Re: *Former Kast Property, Case No. SCP 1230 – Submission of the Revised Remedial Action Plan
and Associated Documents*

REVISED REMEDIAL ACTION PLAN

APPENDIX A

CONCEPTUAL REMEDIATION AT A RESIDENCE -
5-FT EXCAVATION, 5 TO 10-FT TARGETED
EXCAVATION, AND SVE/BIOVENTING
PLAN VIEW

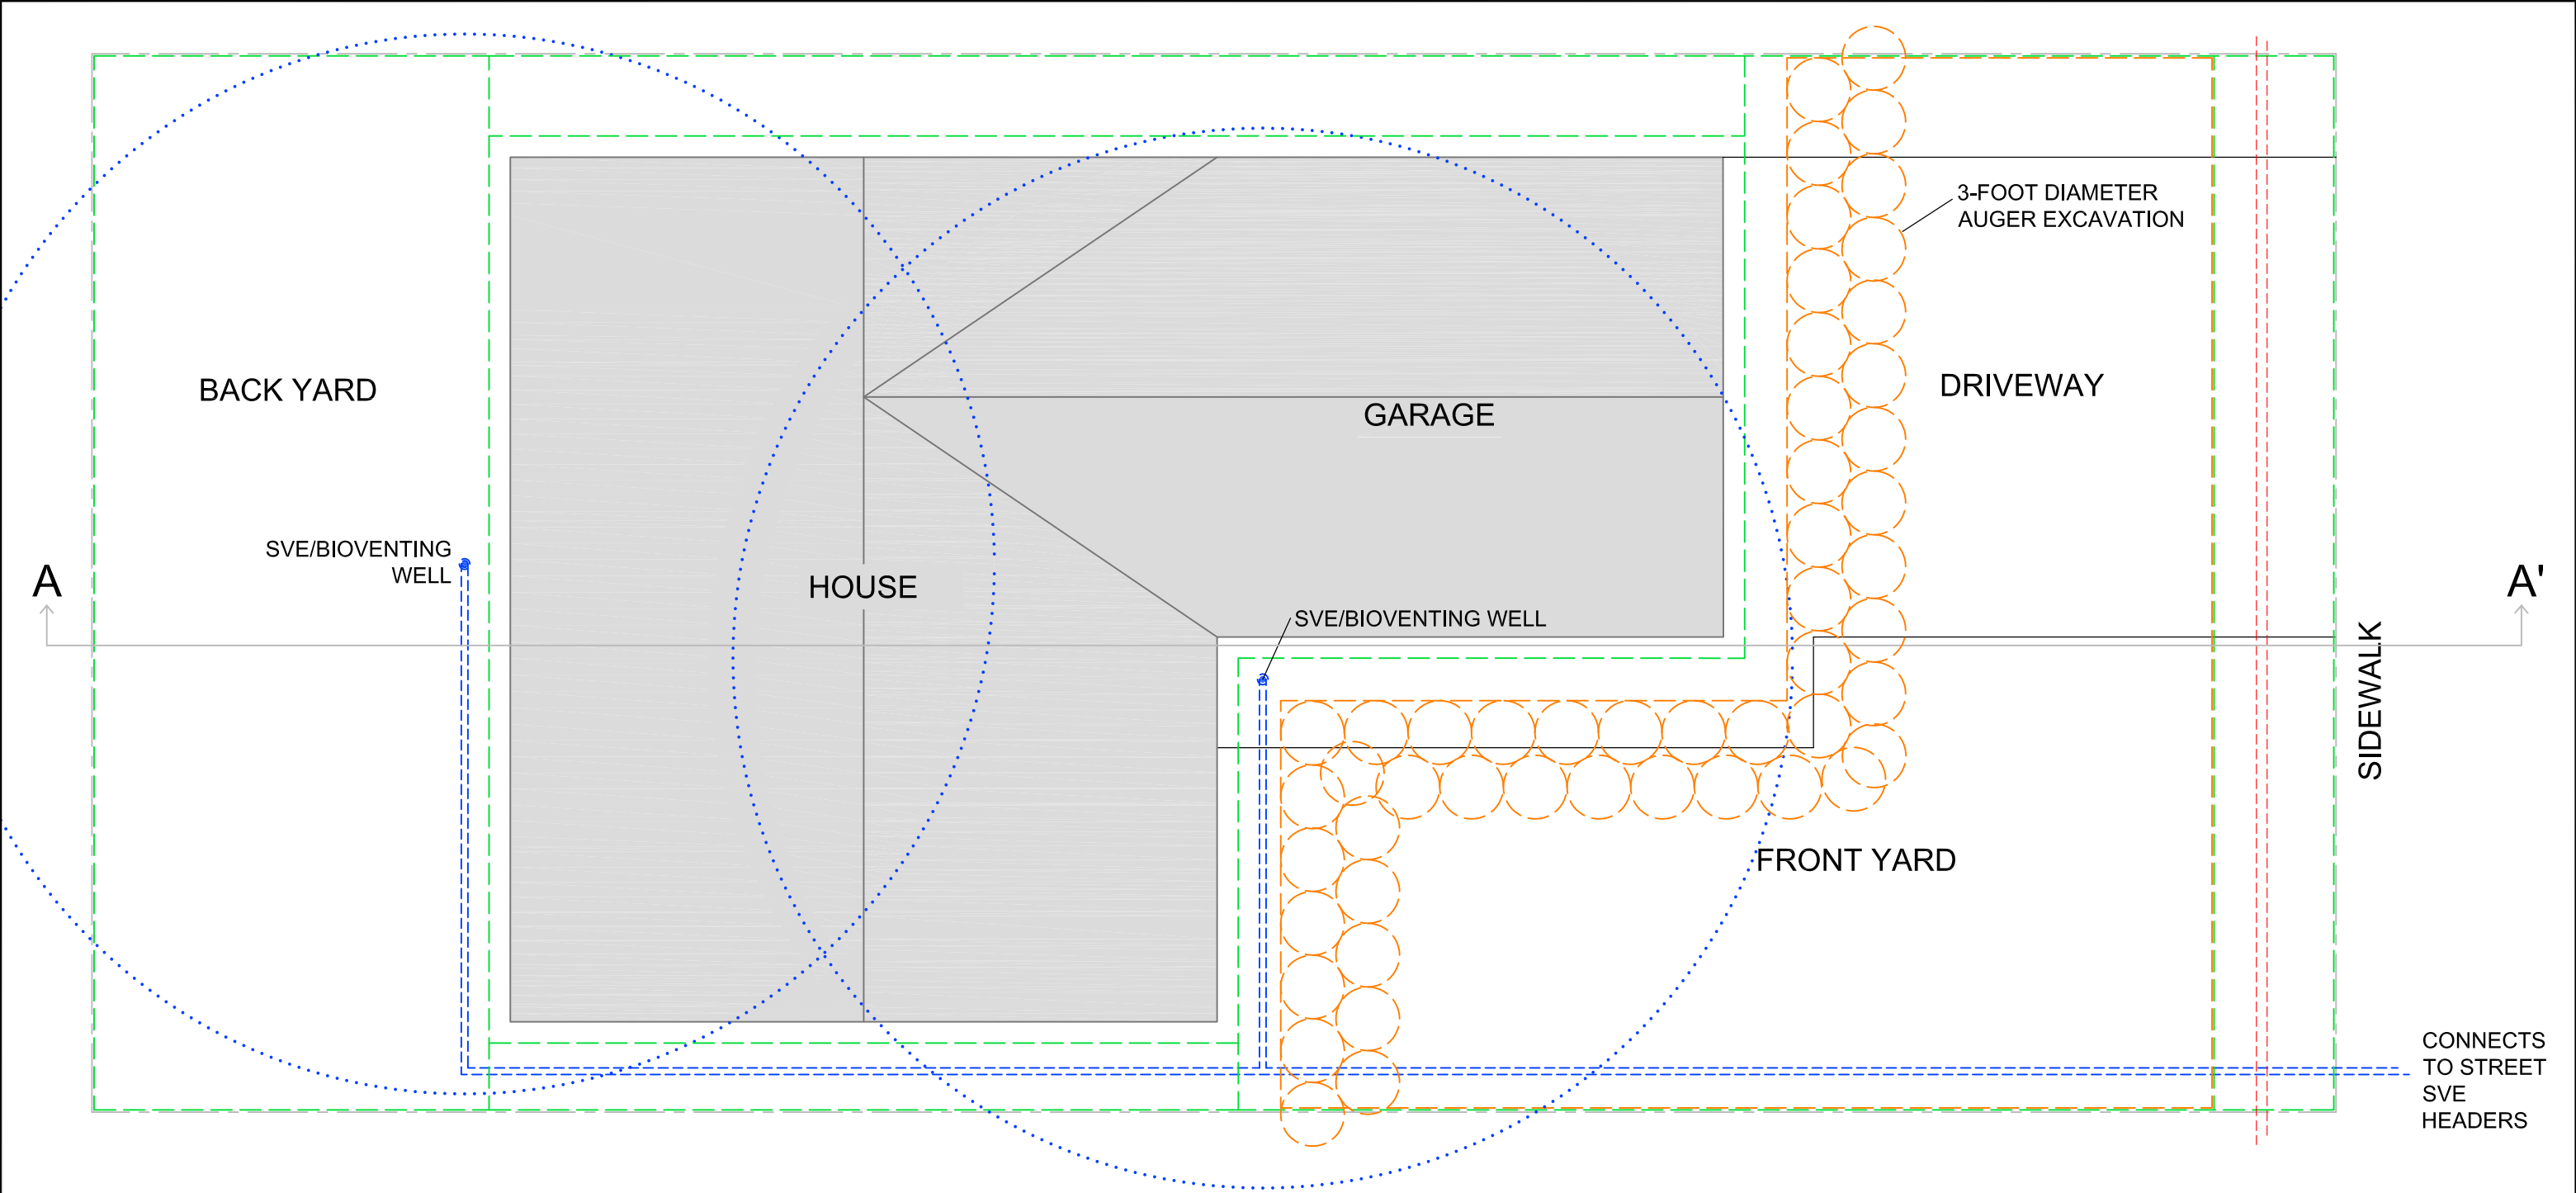
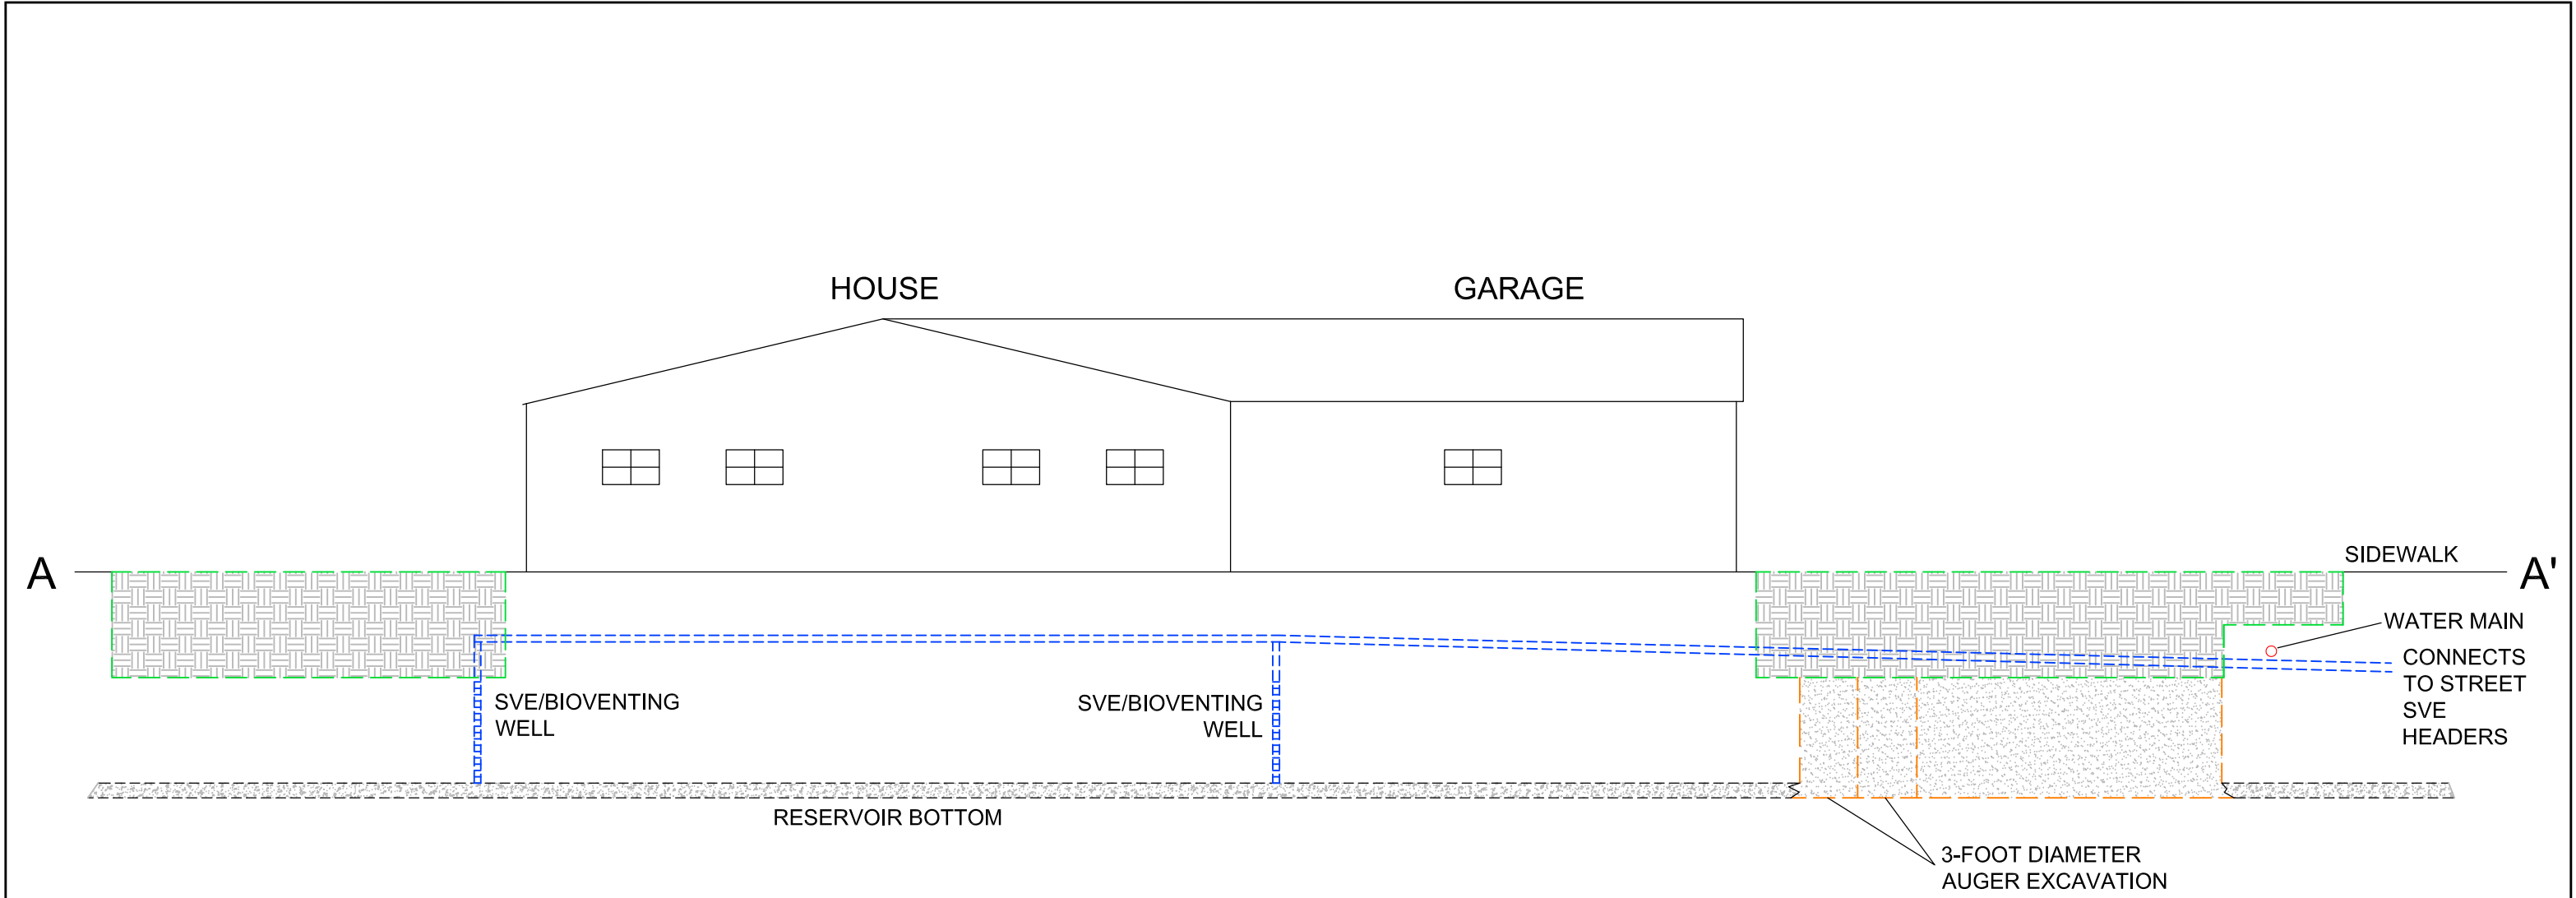
RWQCB-34	Page 15 Conclusion and	<i>Provides a concept rendering of how the cleanup infrastructure will be placed at a</i>	Plan view and cross-section schematic views of a typical residence soil excavation and	Revised RAP Figures 8-6

Comment No.	Regulatory Comment Page Number and Section	Regulatory Comments	Response	Revised Section(s)
	Directive Number 4 for Revised RAP	<i>typical individual residence.</i>	SVE/bioventing well system installation and soil excavation details have been provided.	and 8-7
RWQCB-35	Page 15 Conclusion and Directive Number 5 for Revised RAP	<i>Provides a contingent location for SVE/bioventing treatment facility should an on-site location not be available.</i>	Please refer to the response to the previous comment RWQCB-16.	Revised RAP Section 8.2.2 and Figure 8-8
RWQCB-36	Page 15 Conclusion and Directive Number 6 for Revised RAP	<i>Revises the calculation of the sub-slab to indoor air attenuation factor and re-identifies properties exceeding the lower bound of risk range of 1×10^{-6} or a hazard index of 1, based on the more protective SSCG for soil vapor and sub-slab soil vapor for consideration of sub-slab mitigation.</i>	The Revised HHRA has also been revised to clarify the use of the Regional Board-approved soil vapor SSCGs. An updated assessment of the sub-slab soil vapor to indoor air attenuation factor is presented in Appendix D of the HHRA. This updated assessment demonstrates that an attenuation factor of 0.002 is a conservative upper-bound value based on evaluation of the empirical data (i.e., sub-slab and indoor air concentration measurements) collected at the Site.	Revised HHRA, Appendix D and Section 6.3
